Noren Pinehurst

Design Review Meeting
11202 Roosevelt Way NE
DPD #3019728

Response to Board:

Commercial Streetscape Experience
(Street to Live/Work)

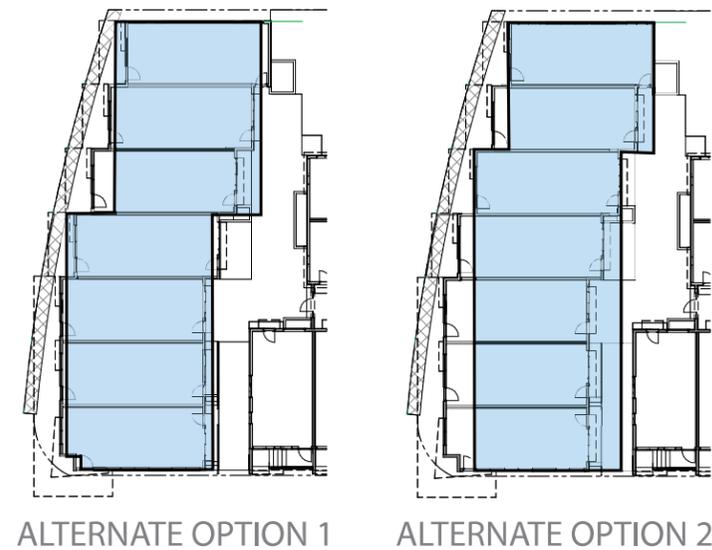
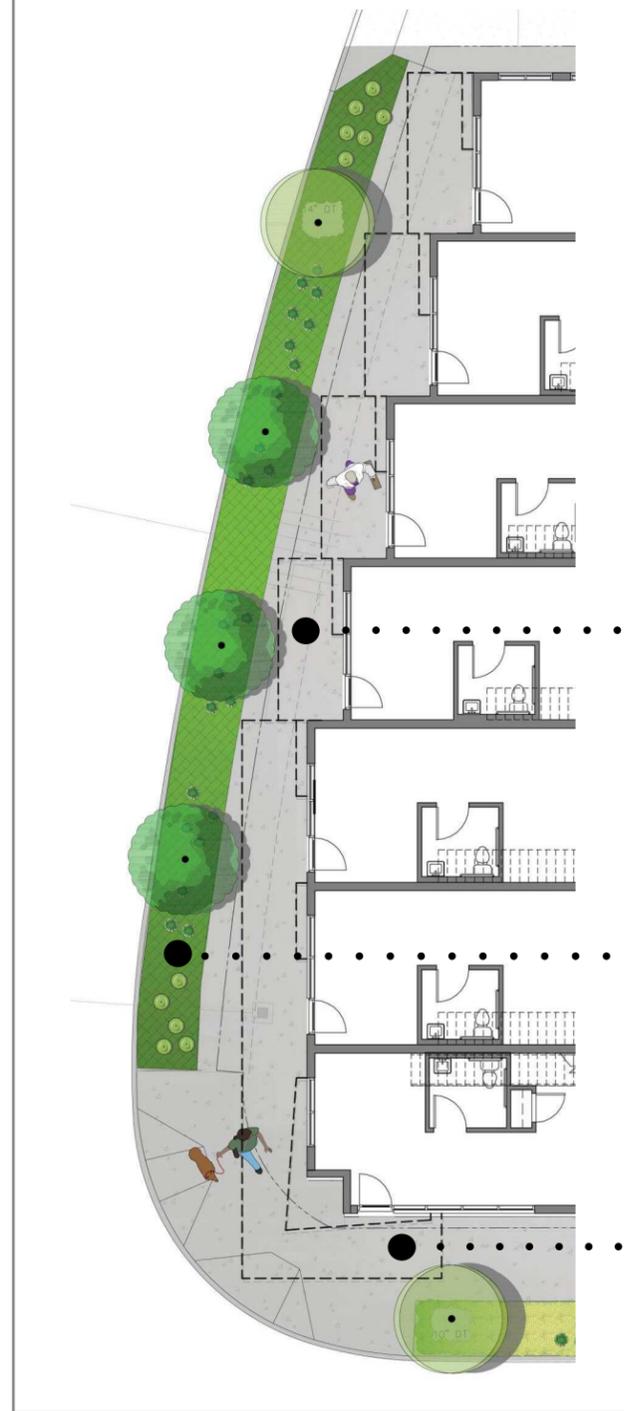
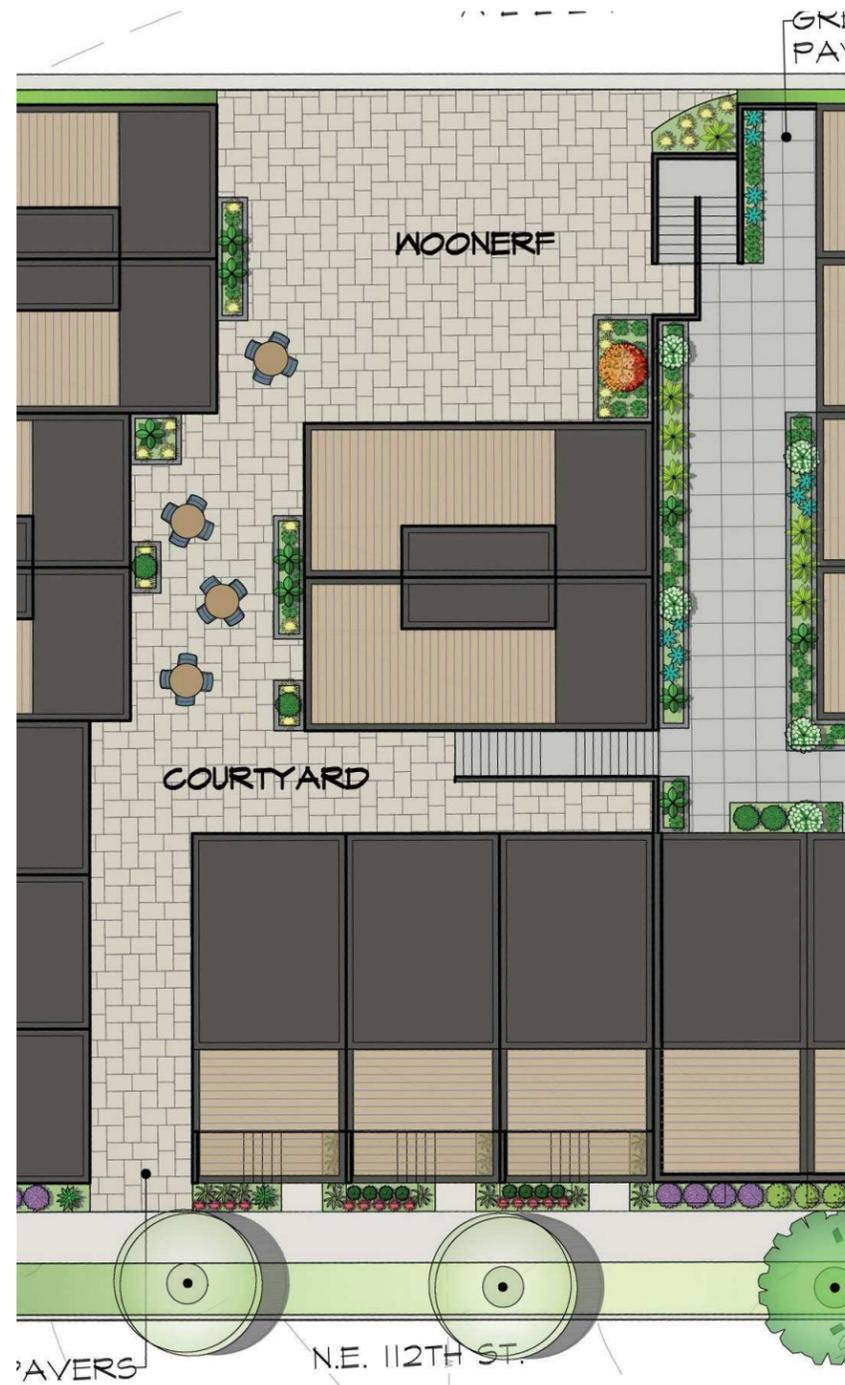
- 1.b: Further develop the ground level setback, upper level overhang, and overhead wether protection along Roosevelt Way NE.
- 1.c: Adjust the landscape to provide an intervening landscape buffer between the street and the sidewalk, allowing the live/work uses to spill out to the sidewalk.
- 1.d: Explore shifting the western structure closer to Roosevelt Way NE, possibly creating two setbacks instead of three setbacks.

As shown in the diagrams above, we have explored the number of steps in Building 1. Since the EDG design contained two steps, we explored reducing the steps further. In both options, reducing the building steps also reduces the usability of the Urban Alley. This is shown where the blue translucent pattern overlaps the walls of the current design below it.

Moving the structure farther west, as the Board recommended, naturally creates more steps in the building rather than fewer. The design team has embraced this as a feature of the building concept that follows the natural curve of Roosevelt Way NE. This also creates an eye-catching accordion affect as one drives or walks past the site, gradually showing the color slices along the facade.

The sidewalk in front of the Livework Units has been increased to allow the Commercial uses to spill out to the sidewalk. This will activate this space as a commercial use, and will catch the attention of passersby.

A six foot landscape buffer has been located between Roosevelt Way NE and the Livework entries, shielding the pedestrians from the busy arterial.

Six foot metal canopies will be provided at each Livework entry to protect passersby as well as the commercial customers.

Commercial Streetscape Experience
(Live/Work to Urban Alley)

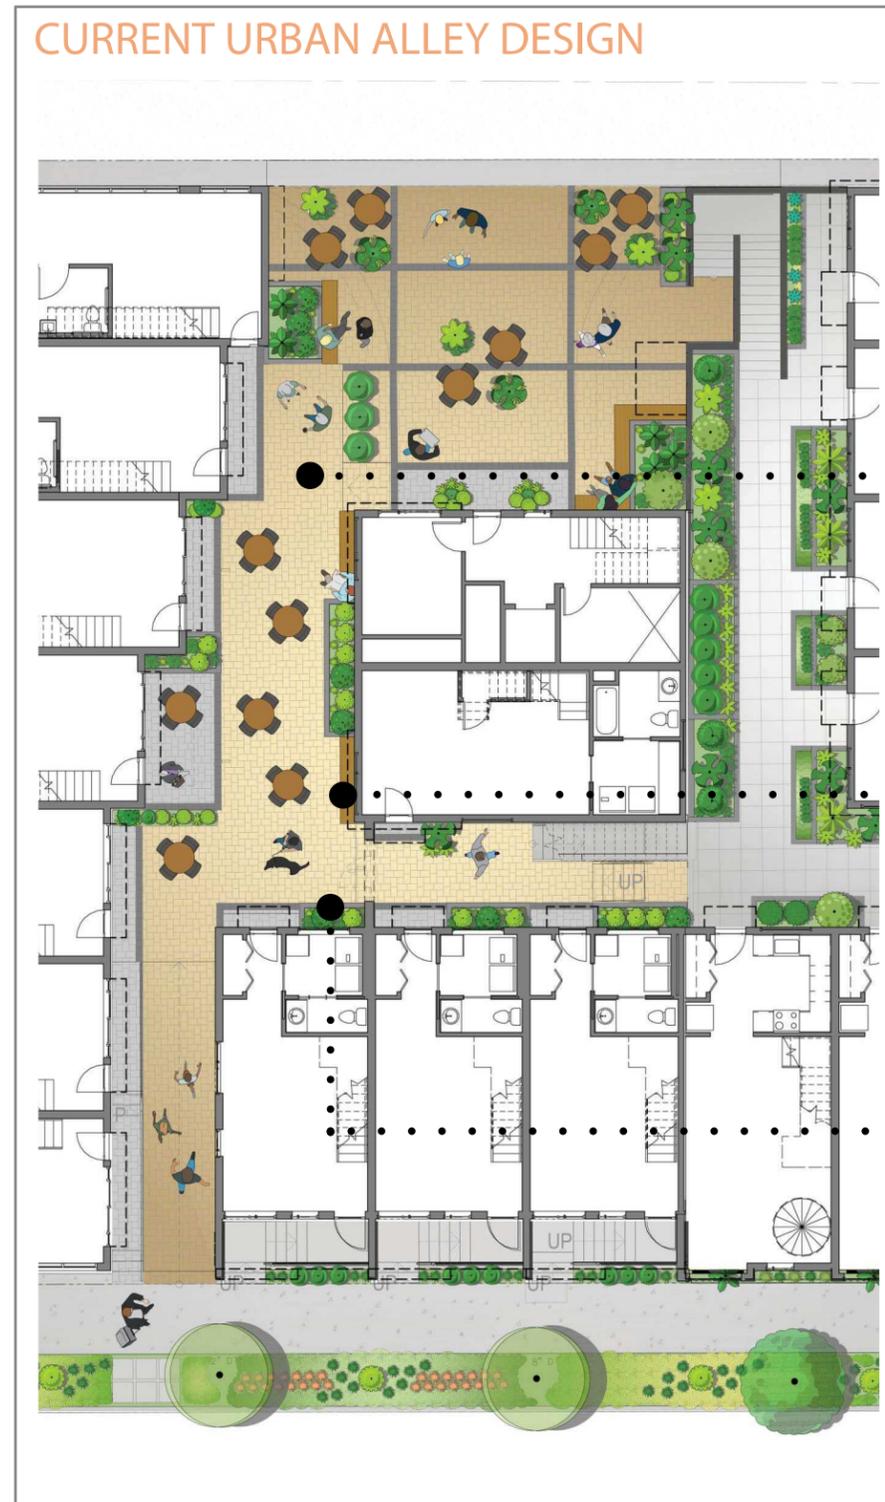
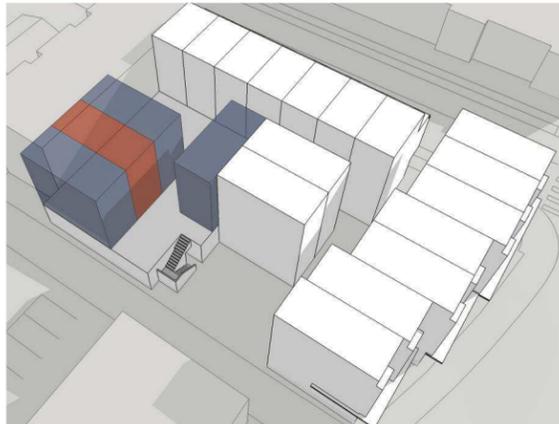
- 4.a: Soften the internal spaces by including additional landscaping
- 4.c: Design the units adjacent to the woonerf and Urban Alley in a way that will encourage uses, such as cafe seating, to spill out onto the public spaces.

The Design Team embraced the Board's concerns regarding the access from the Livework Units to the Urban Alley. Large sliding glass doors with relites have been added to the eastern sides of the Livework Units to create maximum light and visibility into the Urban Alley.

Wall sconces, metal canopies, signage, and ample public seating have been added to these units so that the entrances along the Urban Alley is just as inviting as along Roosevelt Way NE.

Maximum landscaping has been incorporated into the Urban Alley and Podium spaces to soften the space and encourage "spill-out" from the Livework units.

Orientation of Units on Top of Podium

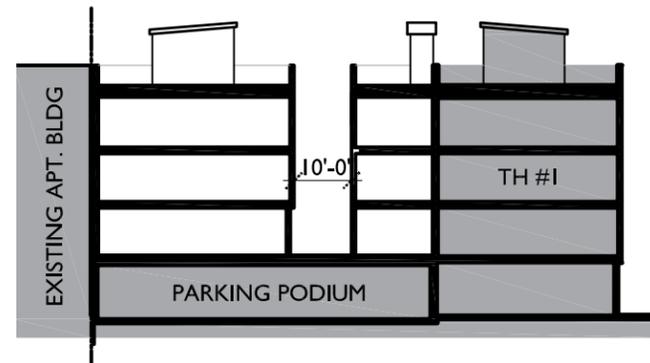
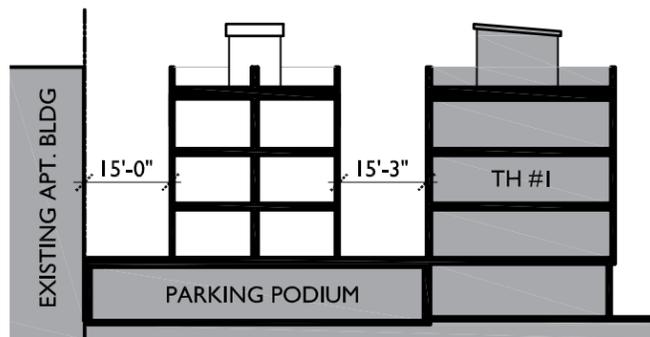
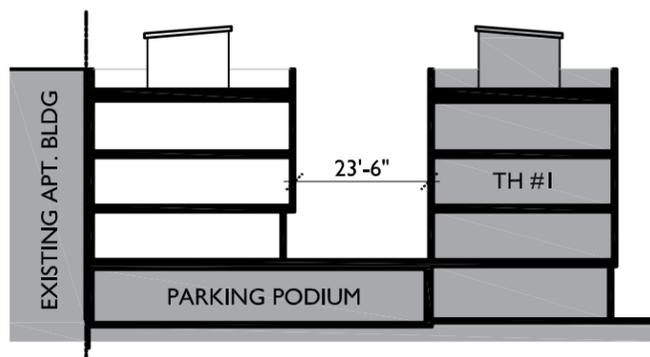
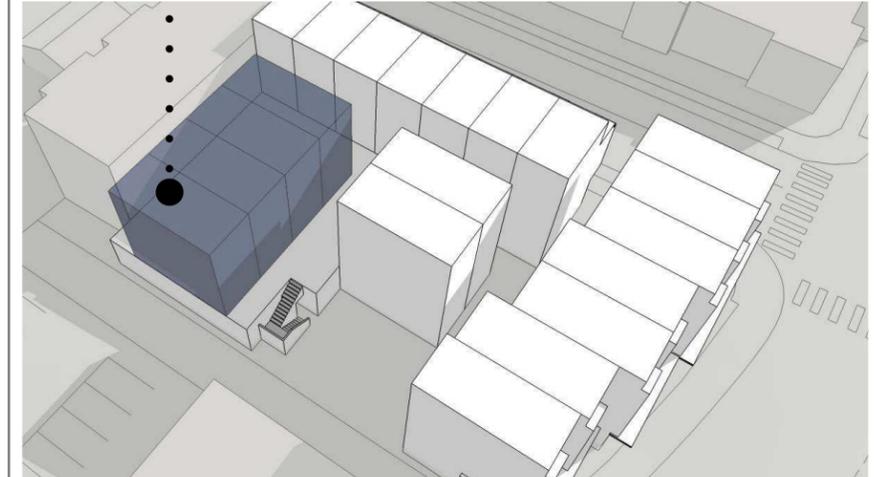
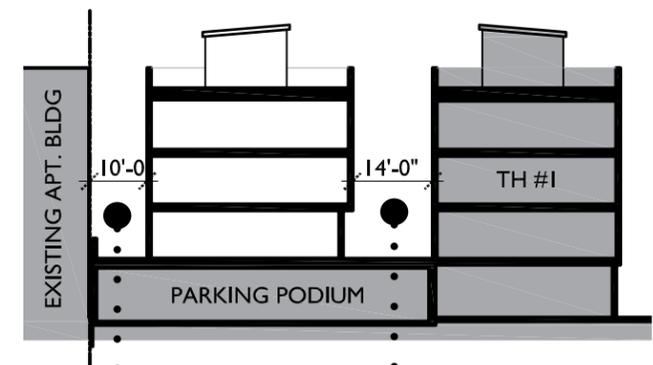
- 3.a: The Board expressed concern with the orientation and siting of the internal townhome units and their relationship to the woonerf/turnaround and existing blank wall condition to the east. The Board directed the applicant to explore ways to rotate or reorient the internal townhome units to minimize the impacts from the existing blank wall and create the most successful outdoor spaces.

- SITING AND REORIENTATION:** The most efficient and aesthetic design comes from treating the podium units as one group, allowing for glazing on all sides and a consistent design. As shown in Alternate Options 1 + 2, the broken up units create odd pocket spaces that interrupt the overall concept of the site.

BLANK WALL: The current design respects the neighbors request of leaving access to the utilities mounted on their building, while accenting the wall with vegetation. The neighboring apartment can act as part of a lightwell for the maximum glazing that has been added to the East side of the podium building.

- SUCCESSFUL OUTDOOR SPACE:** The proposed design allows for outdoor space at the front and back of each unit, allowing for maximum glazing opportunities where the Alternate Options do not.

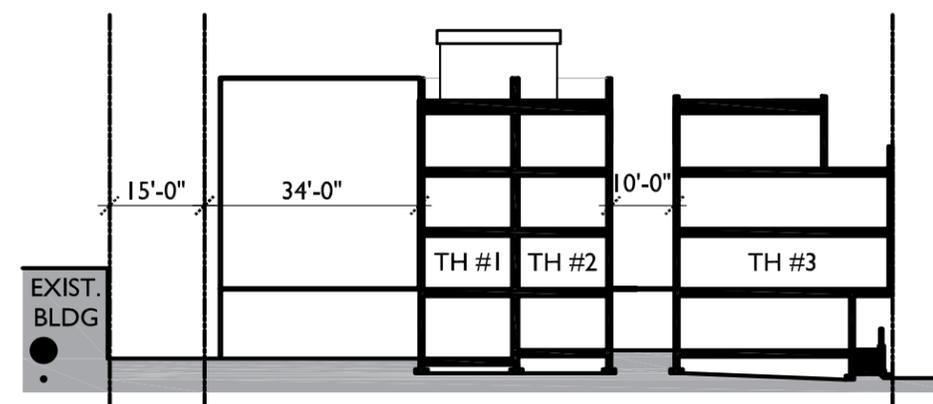
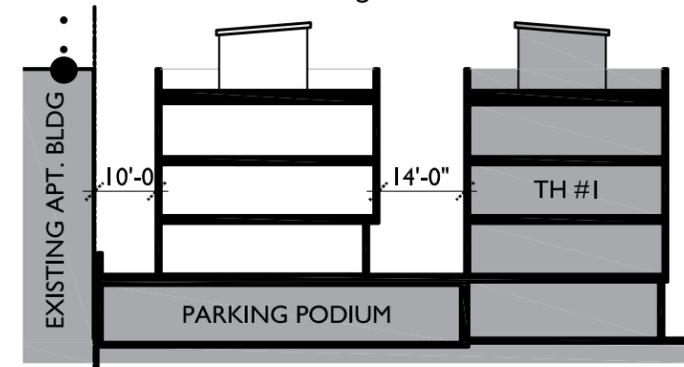
- 3.a: The Board directed the applicant to explore ways to rotate or reorient the internal townhome units to minimize the impacts from the existing blank wall and create the most successful outdoor spaces.
- 4.a: Soften the internal spaces by including additional landscaping
- 4.c: Design the units adjacent to the woonerf and Urban Alley in a way that will encourage uses, such as cafe seating, to spill out onto the public spaces.

- • • **EASTERN NEIGHBOR:** Only a small portion of the development is designed to be built directly against the neighboring apartment building to the East, per the request of the owner, to be able to access their building for maintenance.

- • • **NORTHERN NEIGHBOR:** The proposal respects the development directly to the North by creating a pleasant public Woonerf directly across from the building which prevents the building from being completely shaded and gives the neighbor a view of an active courtyard rather than the side of a building.

112th Street Parking Garage Facade

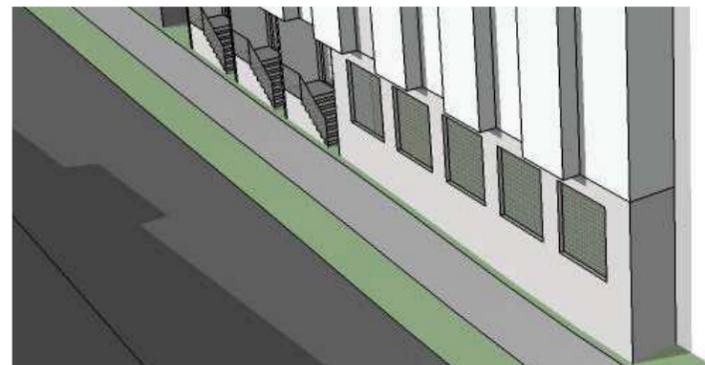
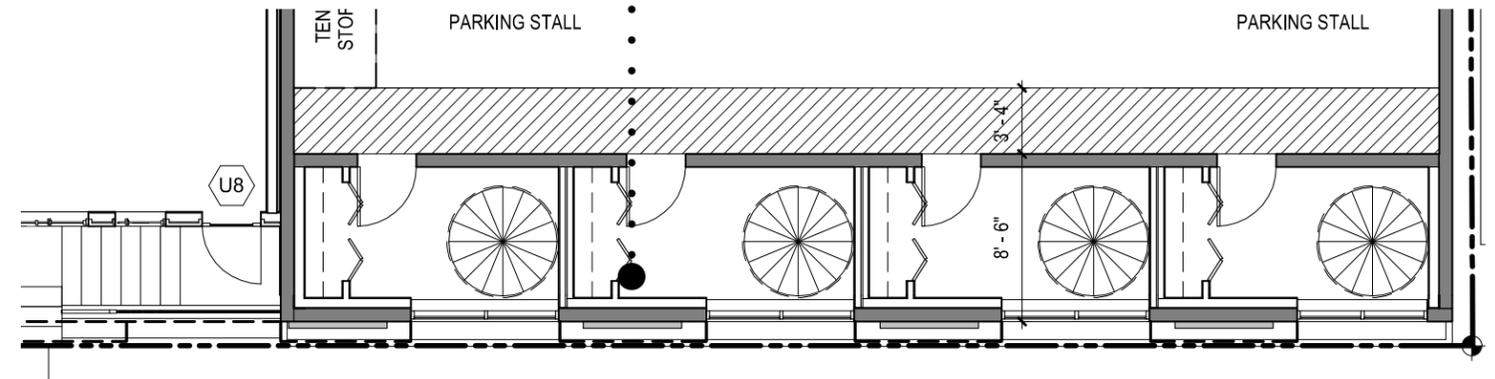
- 2.c: Explore departures for a mix of smaller parking stalls in order to reduce the size of the podium structure.
- 2.b: Explore a residential intervening use, such as a second entry, between the parking structure and the right-of-way.

- • • **INTERVENING USE:** Per the Board's recommendation, the design team has incorporated an intervening residential use between the parking garage and NE 112th Street. A secondary entry has been created from the parking garage into units TH6-TH9, giving these four units a private and covered access to their vehicles.

- • • **SPECIAL EXCEPTION FOR RESIDENTIAL USES:** A Special Exception has been submitted to Janet Oslund (Addressing Reviewer) and Emily Loftstedt (Zoning Reviewer) to increase the percentage of residential use along NE 112th Street.

- • • **BLANK WALL CONDITION:** The current design has presented the opportunity for a mix of large glazing and landscaping along what was originally a concrete street facade. It has reduced the parking garage capacity from 20 to 18 stalls, and now includes 10 compact, 7 medium stalls, and 1 accessible van stall instead of the original 20 medium sized stalls. Typical stall dimensions are shown on the First Floor Plan in this packet.

Woonerf (SDOT Turnaround)

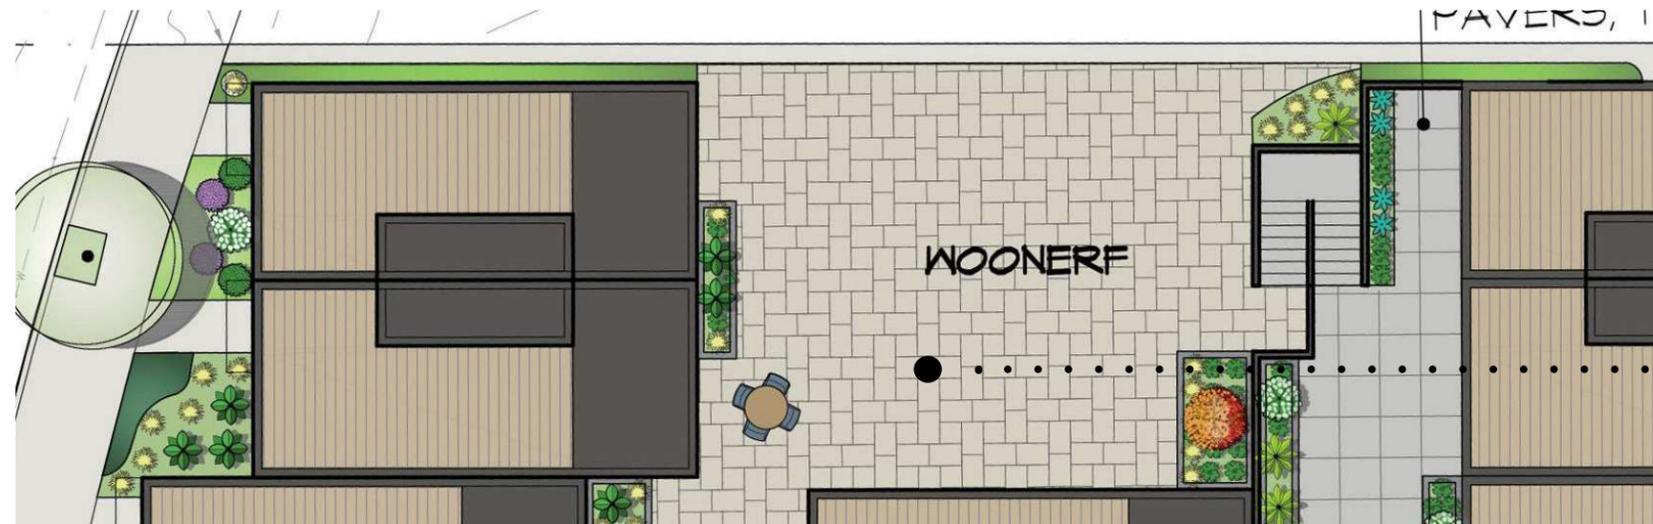
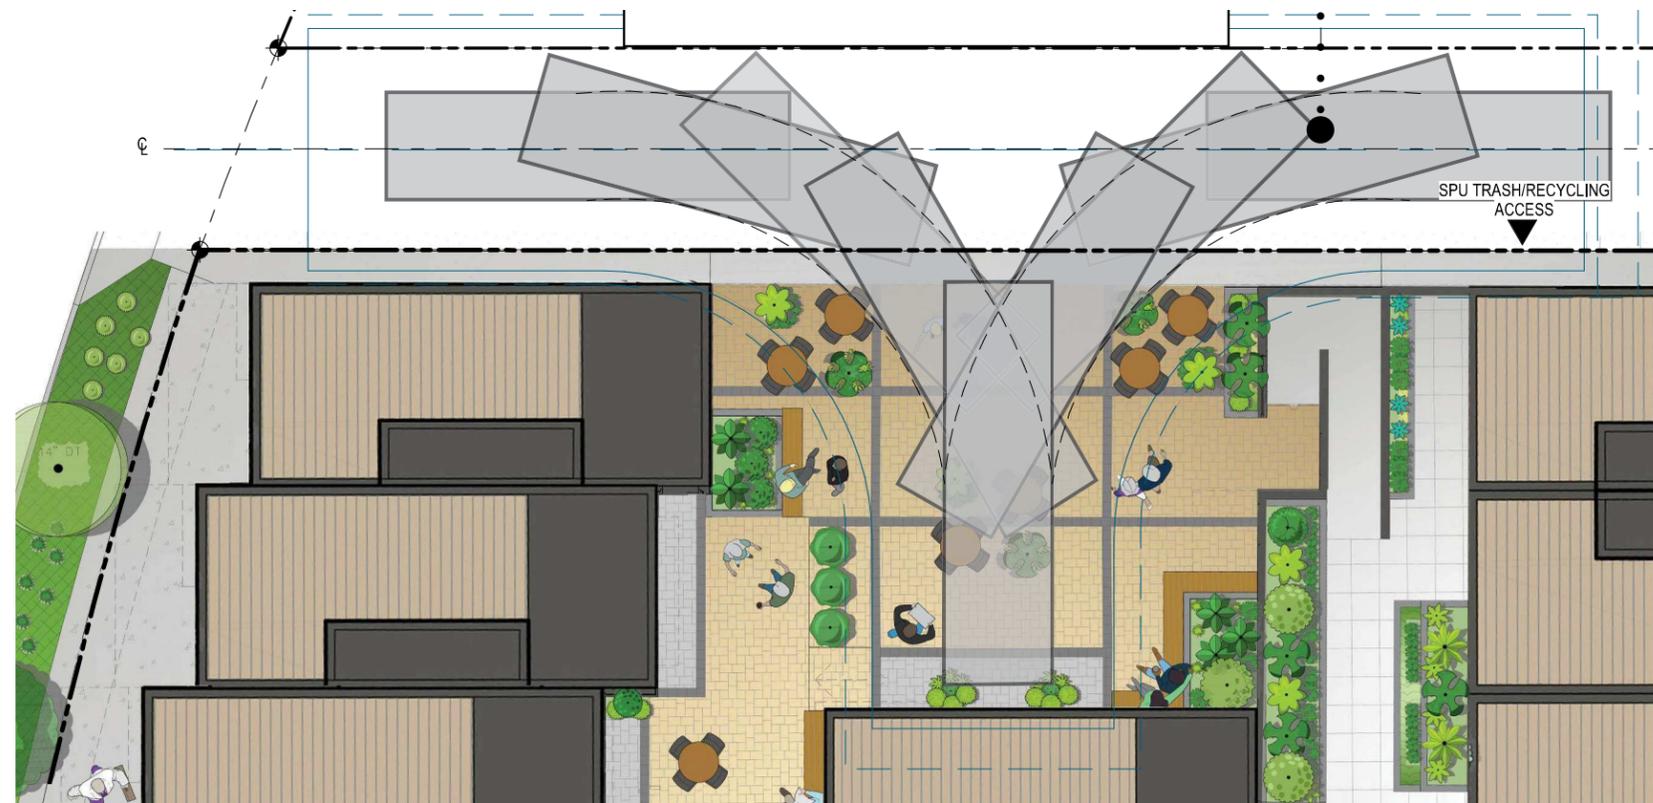
- 3.b: Provide additional context on how the proposal responds to the adjacent uses and development, including vignettes.
- 4.b: Provide additional information on how the woonerf and turnaround will function and details on the landscape/hardscape

..... **WOONERF LANDSCAPE:** A mix of permanent and moveable public seating and planters have been added in comparison to what was proposed at EDG, in order to liven up the Woonerf space and encourage activity spilling from the Urban Alley. The moveable planters can be rolled to different areas of the Woonerf and Urban Alley to clear the SDOT turnaround for SPU access.

..... **WOONERF HARDSCAPE:** While the Woonerf space functions as an SDOT turnaround, the intent of the paving is to welcome tenant uses and activity, delineating between unit entries or and the public activity spaces.
